**8th CSPCWG Meeting
Turku, Finland, 29 November – 2 December 2011**

Paper for Consideration by CSPWG

Physical and Safe Clearance Heights of Overhead Cables

Submitted by:	UNITED STATES
Executive Summary:	Some IHO Member States indicate a “safe vertical clearance” for overhead power cables on nautical charts. Other Member States indicate a “physical vertical clearance” for overhead power cables on their charts. As pointed out by Sweden, this distinction may not be clear to many mariners. This paper suggests some possible actions that might assist chart users in understanding the meaning of clearance symbols.
Related Documents:	INT1 (D20, D26, H20); Publication S-4 (B-380, B-380.1, B-382.1); UKHO Chart 5011, Edition 5; Paper CSPWG8-8.11A (Sweden).

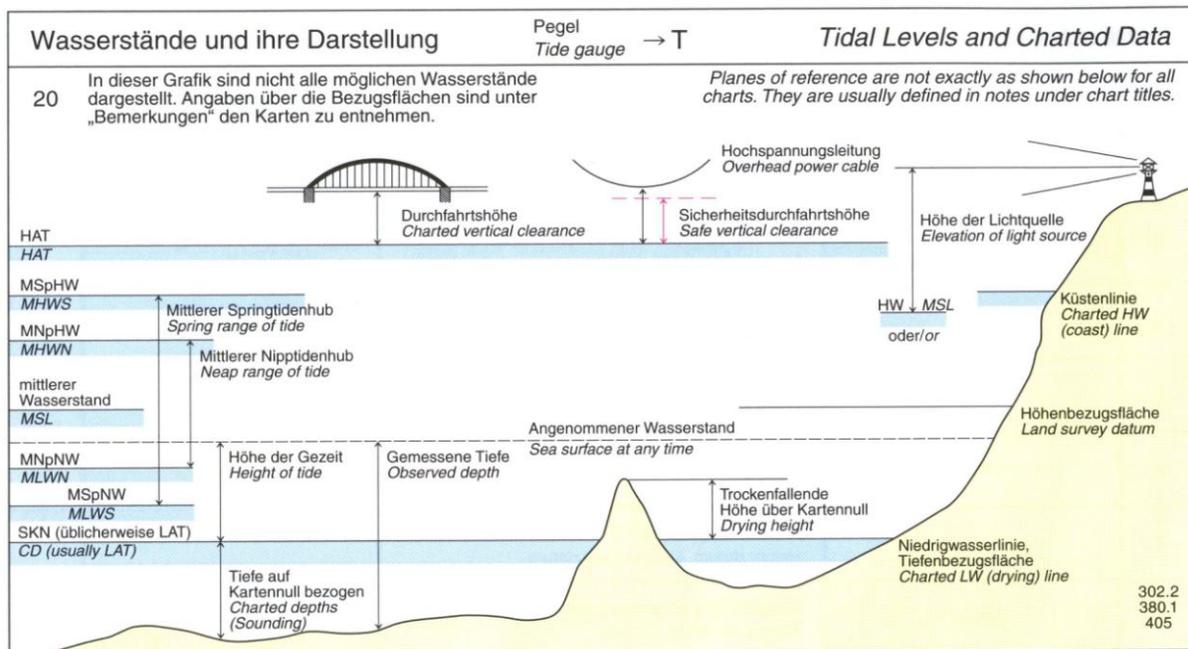
In Paper CSPWG8-08.11A, Sweden expressed doubt that chart users know the difference between an overhead power cable vertical clearance charted in magenta (safe vertical clearance) from an overhead power cable vertical clearance charted in black (physical vertical clearance with no adjustment for risk of an electrical discharge).

An Office of Coast Survey (NOAA) cartographer informally posed this question to a small sample of commercial mariners. The result: none knew the difference in meaning between the black physical vertical clearance symbol and the magenta safe vertical clearance symbol. This could present a dangerous situation for a chart user who mistakes a physical vertical clearance (in black) for a safe vertical clearance (in magenta).

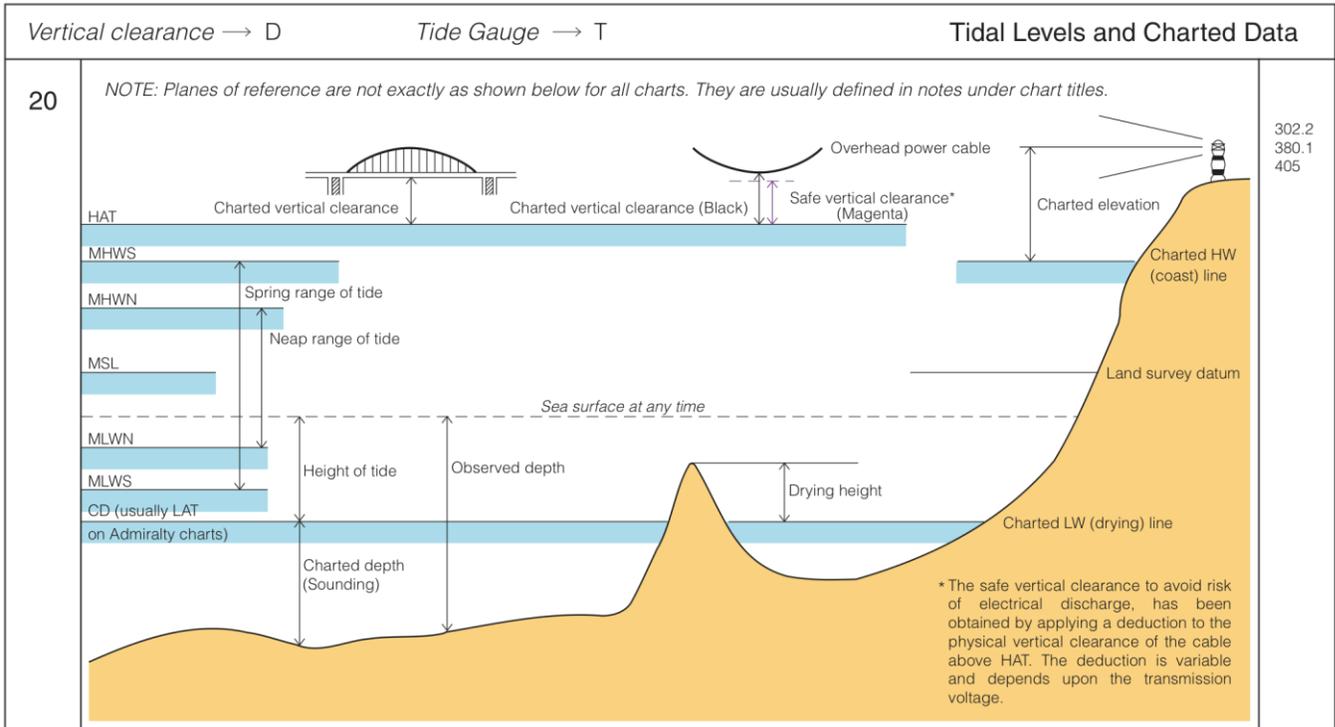
The United Kingdom Hydrographic Office (UKHO) Chart 5011, Symbols and Abbreviations Used on Admiralty Paper Charts, has a similar diagram as Karte 1 at Symbol H 20, but there are some minor differences that may help a chart user to distinguish the difference between a safe vertical clearance and a physical vertical clearance.

In Chart 5011, the label for the safe vertical clearance dimension line includes the word “Magenta” in parentheses.

In Chart 5011, the vertical dimension line for the physical vertical clearance of the overhead power cable is labeled, “Charted vertical clearance (Black).”

In addition, Chart 5011 includes an explanation of safe vertical clearance in the lower right corner of the graphic.

A similar explanation is found in Karte 1 as a footnote to Symbol D 26 (“Overhead power cable with pylons and safe vertical clearance”), but the United States believes that such a statement would also be helpful to chart users at H 20 as is done in Chart 5011. Note that the footnote for the vertical clearances of power cables at D 26 refers back to D 20, which shows **a bridge** symbol. This is potentially confusing.

Perhaps it would also be helpful if the label for the safe vertical clearance vertical dimension line at H 20 could be changed to magenta coloured type.

Also, consider changing “Charted vertical clearance” at the overhead cable (and not the bridge), to “Physical vertical clearance (Black)”, since it may be the magenta safe vertical clearance that is actually charted.
